# NELSON CITY COUNCIL

Proposed Plan Change 17  
Enner Glynn and Upper Brook Valley Rezoning and  
Structure Plan

### **Planning Officers Report - Addressing Submissions on the Plan Change prior to Hearing**

**Date of hearing**  
14 and 15 September 2011

*PHOTO 1: Taken from Higgins/Singleton land that is requested to be removed from landscape overlay, showing view through towards bolt road, sh6 and the coast.*

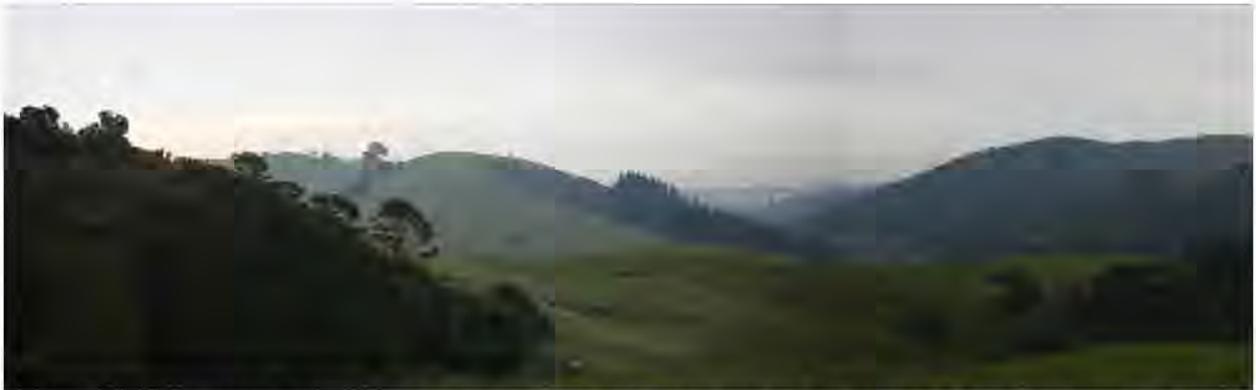
13. Having walked across the land and assessed the visibility from the main transportation routes and the coast, I am satisfied that the landscape overlay as amended through the hearing process for Plan Change 13 has removed the area of low visibility from the landscape overlay. The map as it has been drawn protects the more sensitive areas which are more visible and are seen as part of the larger landscape which forms the green belt behind the Nelson/Stoke urban area. I subsequently have revisited the areas from where this area is visible (Whakatu Drive, Bolt Road, Parkers Road, and the coast) and am comfortable with the current location of the landscape line.

**Figure 1:** Possible amendment to Landscape Overlay addressing Butler late submission. See Photo 2 above.

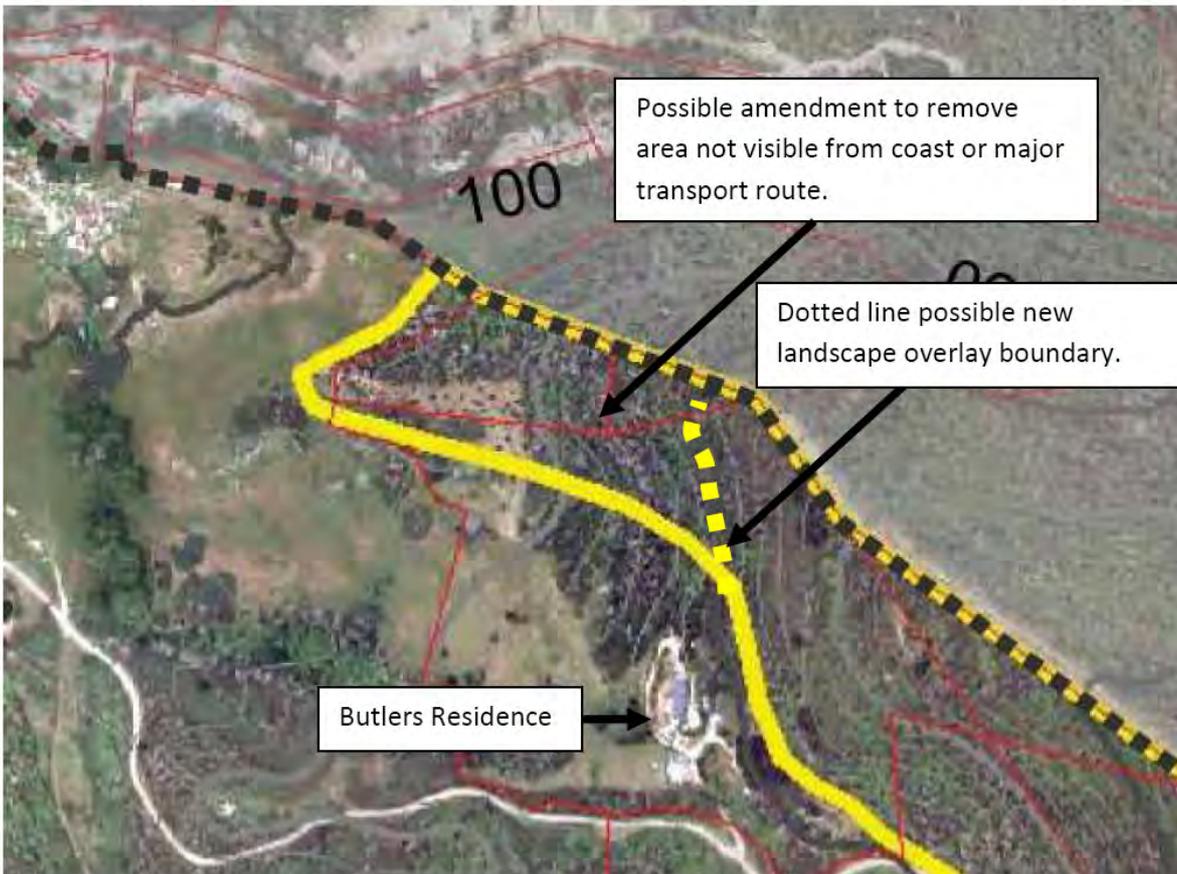
15. When initially drawing the landscape overlay area, I considered that the shoulder ridgeline to the height shown on the landscape overlay plan was sensitive to development and warranted inclusion in the landscape overlay due to its visibility from the urban area, from traffic corridors, pedestrian precincts, public open space and private property (as described in Issues R15 iii). Its value relates to its importance as part of Jenkins Hill, and the larger “continuous vegetation cover” that forms the greenbelt backdrop to Nelson and Stoke, and is a sensitive ridgeline due to the fact that the spine faces Brook Street and is highly visible from this Residential area.

16. If the Council determined that the landscape overlay was too low in this area (due to the fact that it is not visible from a major transportation route or the coast), and that it should be lifted up, I have suggested an alternative landscape overlay area. This area represents views from the surrounding landscape including SH6, the coast, Main Road Stoke, Richmond township and the extent of the long distant views gained through the valley from Appleby and Richmond from State Highway 60 and State Highway 6. This would largely follow the 200m contour until it hits the ridgeline of Jenkins Hill, which is situated above the Butler Residence as seen in *Figure 1* above.

Map showing requested area of Residential Zoning from Submission 11.3 Sharon Higgins and Tony Singleton.

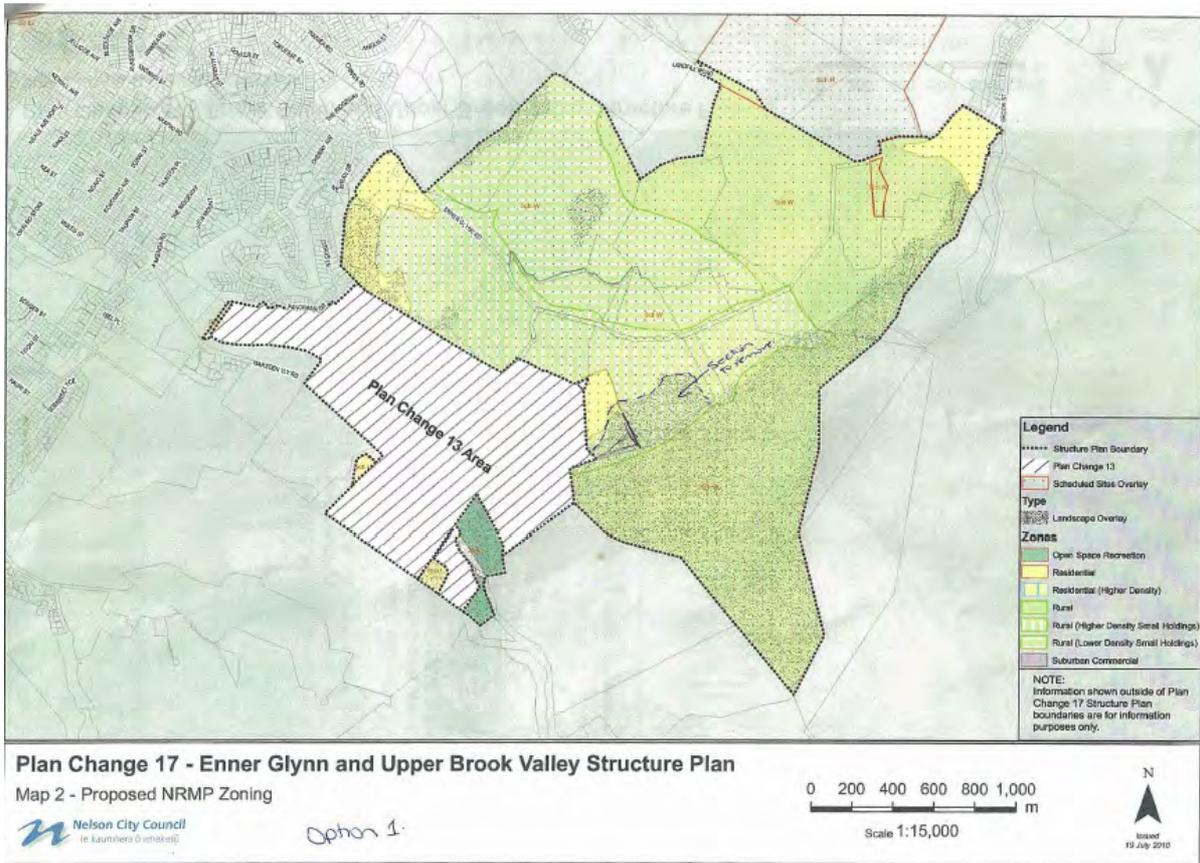
**Submission Point #11.4:** Support in part: DO5.1.2.iv 'The width of corridors will vary for this reason: a minimum width of 20m is required.' As a property owner involved in this Plan Change 17 we are concerned with the requirement for a 20m minimum width. I have attached a copy of Map 3 with my submission and highlighted the three proposed Biodiversity Corridors that will feature on our property. (see full submission for copy of map).

**Decision Sought:** DO5.1.2.iv The width of corridors will vary for this reason: a minimum width of 20m is required. Remove the last part of the sentence, so that no minimum width is quoted, or add a clause that states that the minimum width of 20m can be reduced for Corridors 1 and 2. DO5.1.2.iv Clarification on how our unique situation will be over come when property boundaries will run through the middle of Biodiversity Corridors, will these corridors be able to remain in private ownership, will the developer only need to provide half of the corridor and the other half will get provided later from the neighbour when/if the property is developed. Biodiversity Corridors should allow walkway/cycleways to coexist within the overlay when there is no practical, viable alternative route available.

Landscape Overlay Option 1 and 2. Submission 11.8

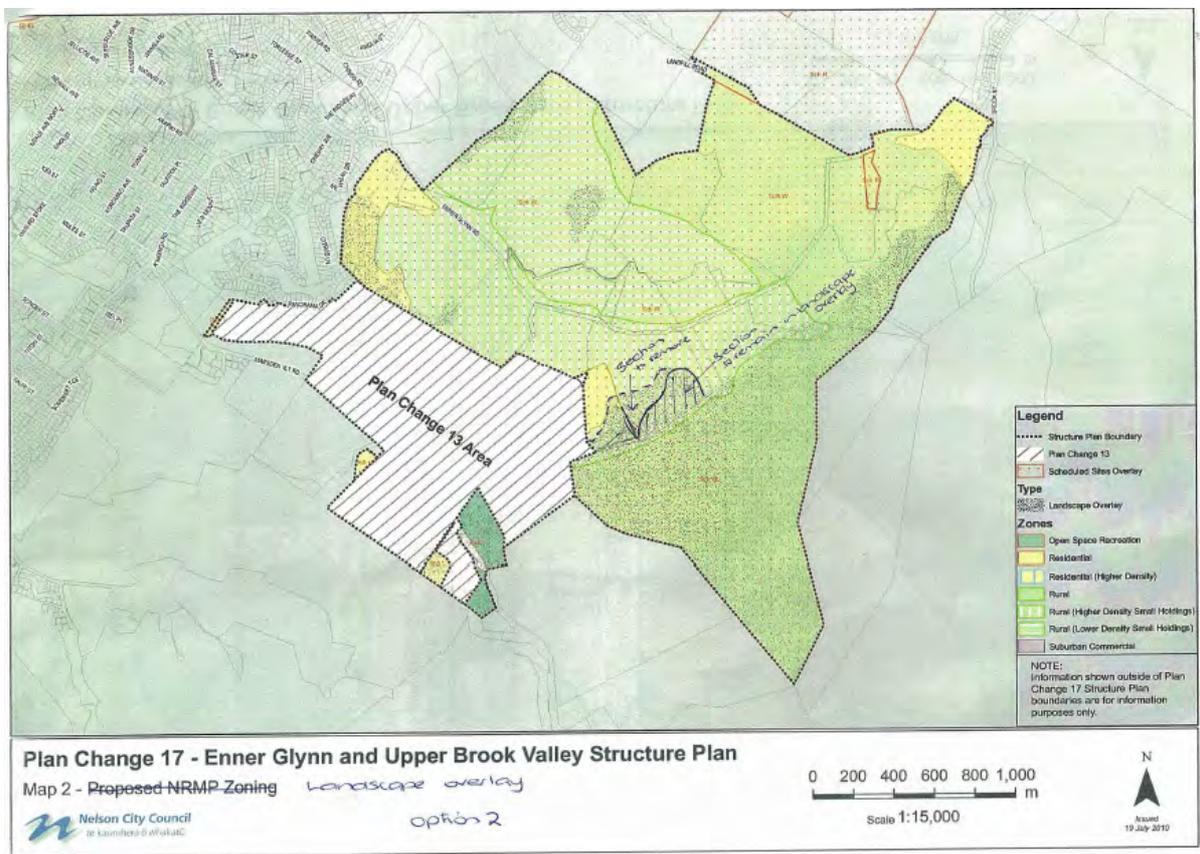
12. This area of landscape overlay was reassessed during the Marsden Valley Plan Change (Plan Change 13) and the extent of it has already been reduced as shown on the Plan Change 17 map attached to my evidence (see Attachment A).
